SUBMITTAL REVIEW COMMENTS

Date: 4/6/18
 Owner: Northwest Seaport Alliance
 Project: West Sicum Stormwater Treatment
 Contractor: Titon

Submittal Title: Vortex Type Hydrodynamic Separators

Submittal Number: PO#81368
 TE-001 Shop Drawings REV2
 TE-002 Maintenance Schedule

BASIN A
 WEST SITCUM
 SW TREATMENT
 TACOMA, WA

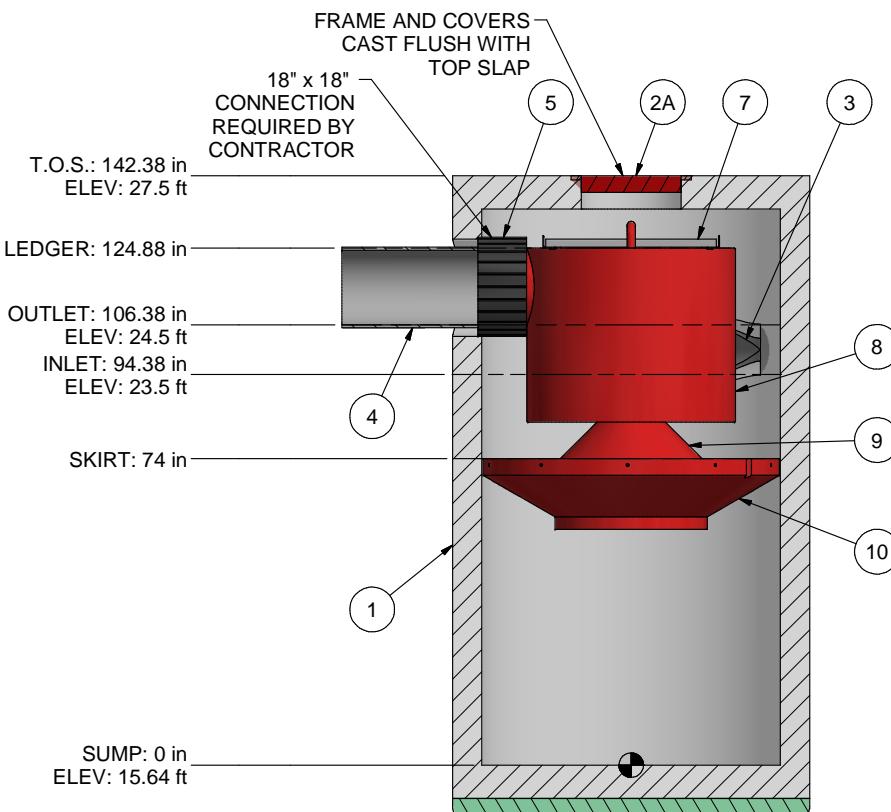
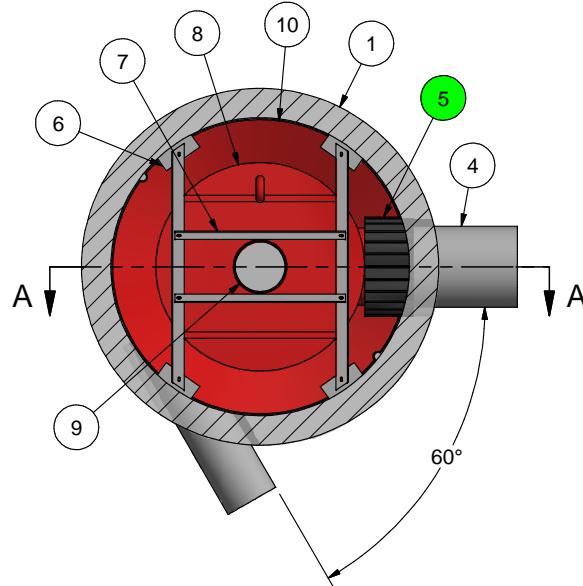
2. Please provide AutoCAD dwg files of the units.
3. Submit cut sheet of proposed eccentric reducing coupling
4. Confirm Titan understands that these HDS units will be installed with the bottom of the pre-cast at or above grade and that the structural calculations will reflect this.

6. The submitted Titan units have angles between the inlet and outlet that do not align with the design for Basins A, B, and C. See sheets M01, M02 and M03. Snips are provided below showing the design angles between the inlet and outlet for all three basins. Provide confirmation that the location of the inlet and outlet is adjustable. Provide any constraints. Provide a proposed re-design to align with our design. We request a conference call with you on this comment prior to you developing a proposed re-design.

- 2) The outlet pipe sizes on your drawing do not match those on the plans. Is it a problem with the functionality of the DD to lower the diameter to match the pipe sizes called out on the plans? **No, it's not a problem hydraulically. The DD has a set outlet stub diameter. To get to 12" and 16" outlet stubs you would need to incorporate an eccentric reducer coupling to use the outlet pipe sizes per plan. NOTE: The outlet invert elevation should remain as detailed per plan (hence the eccentric coupling adapter).**

TITAN to provide an eccentric PVC gasketed reducer coupling to connect the 18.7" OD outlet to the 12" ductile iron (13.2" OD) that will be connected under the installation contract.

BASIN C
WEST SITCUM
SW TREATMENT
TACOMA, WA

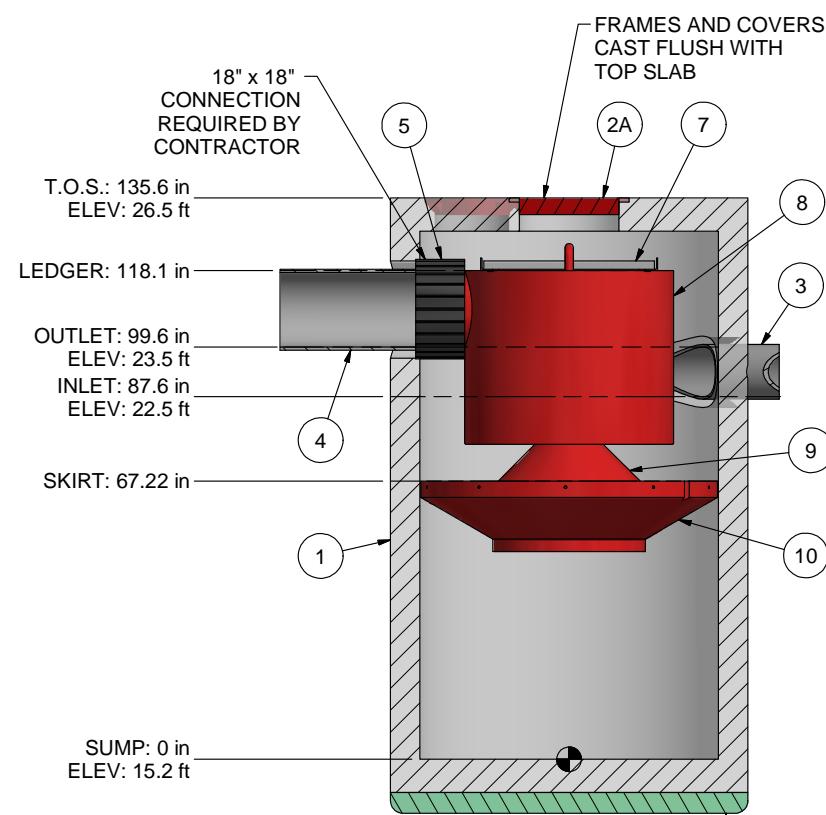
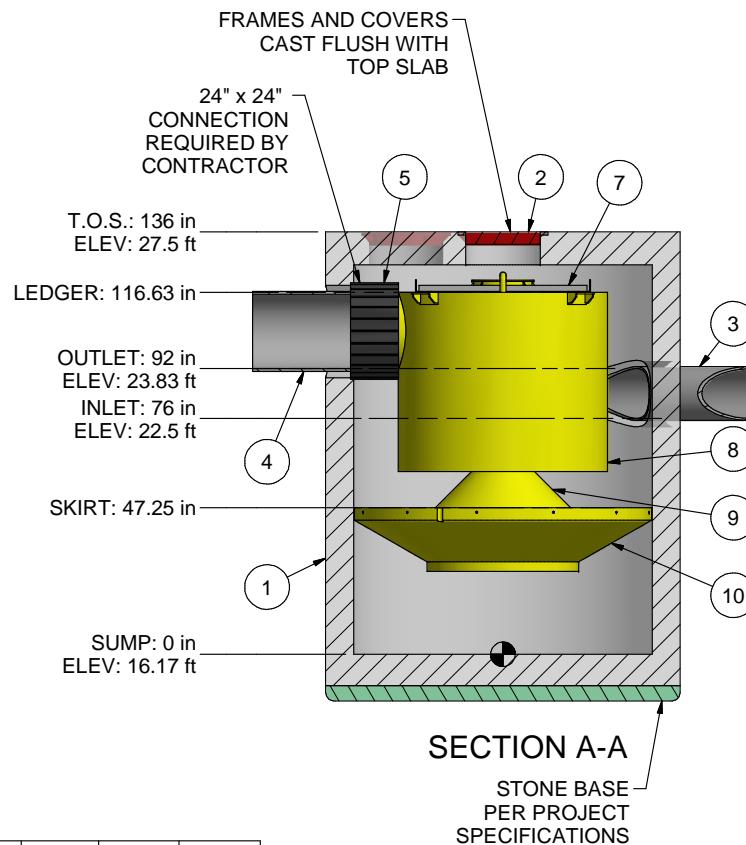
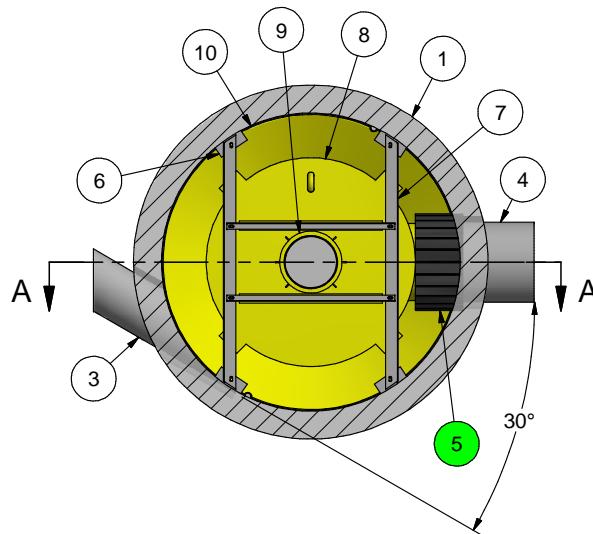
- c. Basin C Specified Inlet/Outlet = 16"/16" vs DD Listed Inlet/Outlet = 16"/24"

TITAN to provide an eccentric PVC gasketed reducer coupling to connect the 24.8" OD outlet to the 16" ductile iron (17.4" OD) that will be connected under the installation contract.
